Statement of Witness

Queensland Floods Commission of Inquiry

Re: Objection to Planning Application OW 6291/2009 & MCU -6293/2009
Address: North & WM Hughes St, North Ipswich
Description:
Applicant: Leda Design and Construction (Qld) Pty Ltd
RPD: Part of Lot 36 on SP175172

**RIVERLINK CENTRAL FLOOD STUDY
48 WM HUGHES STREET, NORTH IPSWICH
RESPONSE TO ADJOINING PROPERTY OWNER**

Neemap image showing "extended platform" (blue) and altered river flow (red)

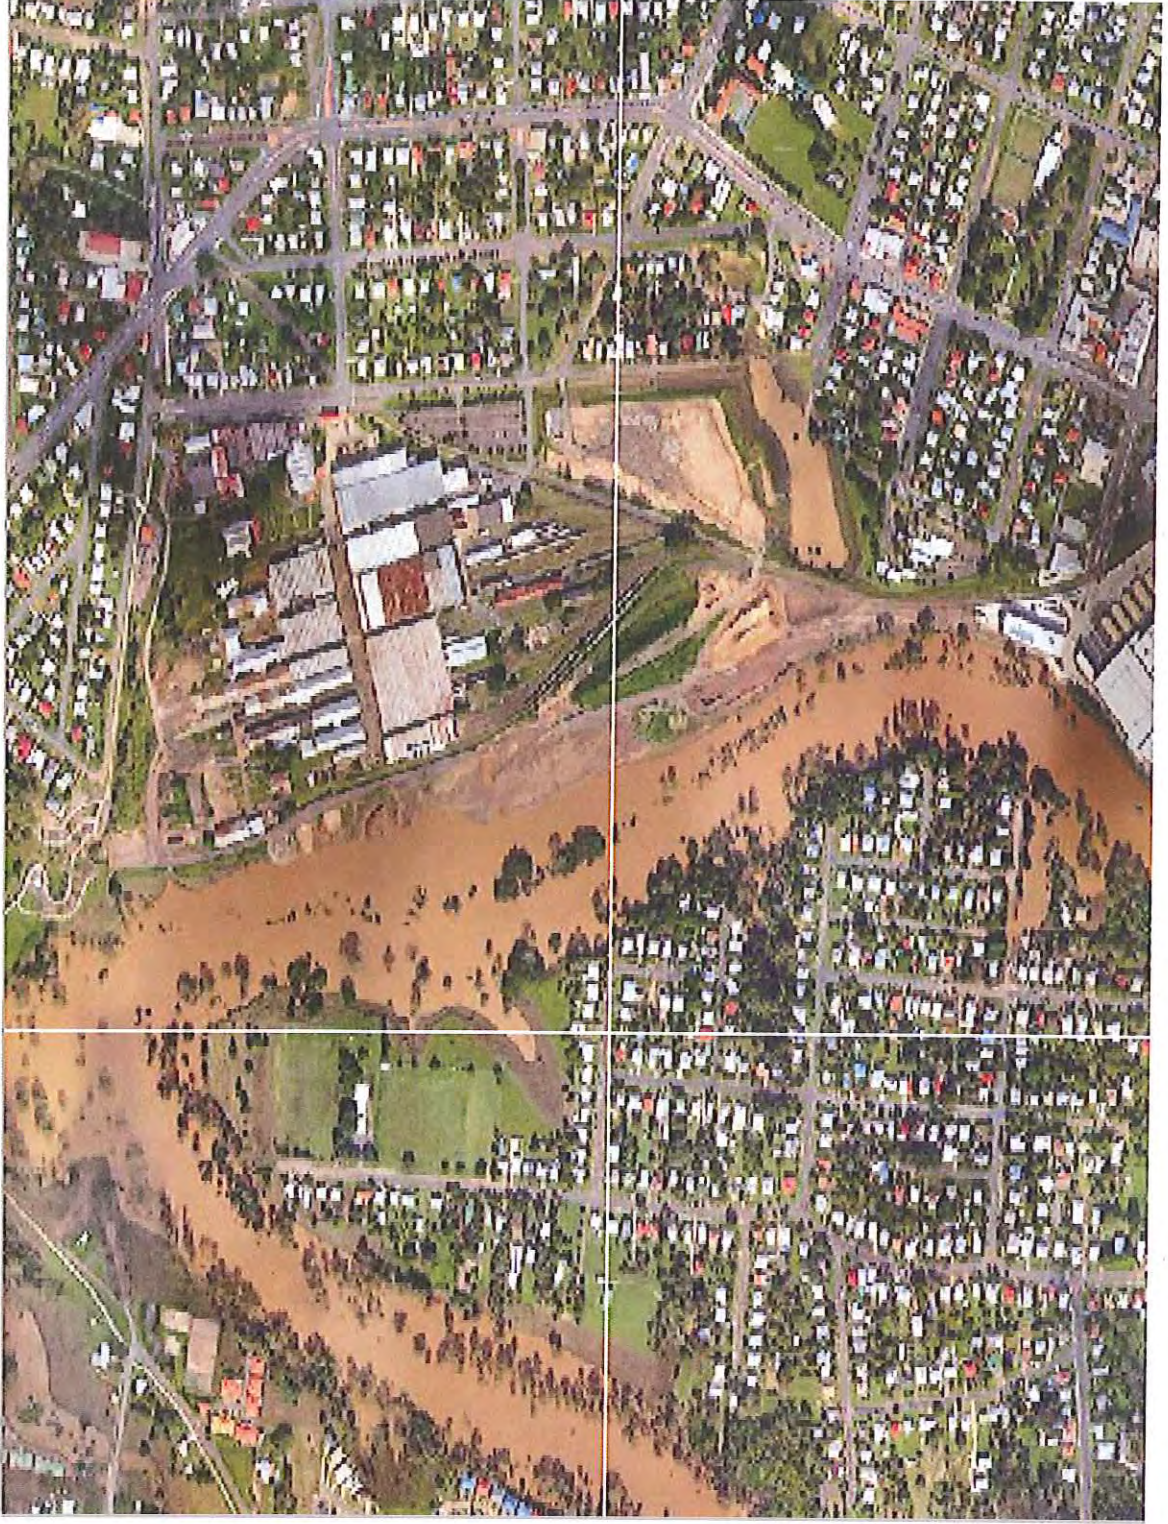
16. On Monday the 21st day of February 2011 I observed work continuing at the proposed site. Since this time the river bank has been extended, creating a platform 19.5 metres above river height. I am able to produce a Riverside central plan and a Nearmap image displaying the elevated platform to 19.5 RL.

In the 2011 flood, the flow patterns observed were strongest on the eastern bank of the river. The effect of the earthworks will redirect these strong flows onto the western bank (Figure 1).
